## **Access Compliance Report Public Rights-of-Way** (Island Curb Cuts)

Intersection ID: 15394 Main Street: HERMAN\_AV Cross Street: S\_TRYON\_ST Location: SE ADA ID: DCD56A07949B **Curb Cut Type: MedianRefuge2** Initial Pass/Fail: Fail **Overall Compliance: No** Severity Score: 22.5

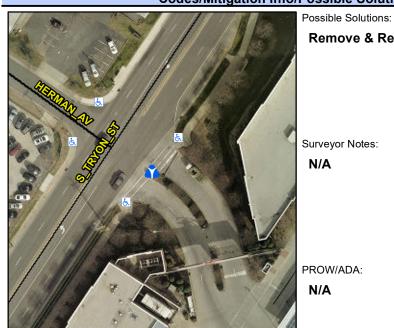
Com	pliance De	scription	Data	Com	pliance	Description	Dat
Yes	Refuge 1 Leng	jth (ln)	37.5	N/A	Gutter '	I Ponding?	N/A
No	Refuge 1 Widt	h (In)	59.0	N/A	Gutter '	I Lip Ht (In)	N/A
Yes	Refuge 1 Slop	e (%)	1.9	N/A	Gutter '	l Slope (%)	N/A
Yes	Refuge 1 X Sl	ope (%)	4.0	N/A	Gutter 1	I X Slope (%)	N/A
N/A	Painted X Wal	k1?	Yes	N/A	DWS 1	Provided?	N/A
N/A	X Walk 1 Direc	ction	To SW	N/A	DWS 1	Contrast?	N/A
N/A	X Walk 1 Widt	h (ln)	62.0	N/A	DWS 1	Length (In)	N/A
N/A	Road 1 Slope	(%)	3.5	N/A	DWS 1	Full Width?	N/A
N/A	Road 1 X Slop	e (%)	4.0	N/A	DWS 1	Offset (In)	N/A
Yes	Refuge 2 Leng	gth (In)	37.5	N/A	Gutter	2 Ponding?	N/A
No	Refuge 2 Widt	h (ln)	59.0	N/A	Gutter 2	2 Lip Ht (In)	N/A
Yes	Refuge 2 Slop	e (%)	2.3	N/A	Gutter 2	2 Slope (%)	N/A
No	Refuge 2 X Slo	ope (%)	5.8	N/A	Gutter 2	2 X Slope (%)	N/A
N/A	Painted X Wal	k2?	Yes	N/A	DWS 2	Provided?	N/A
N/A	X Walk 2 Direc	ction	To NE	N/A	DWS 2	Contrast?	N/A
N/A	X Walk 2 Widt	h (ln)	58.0	N/A	DWS 2	Length (In)	N/A

Remove & Replace Entire Refuge.
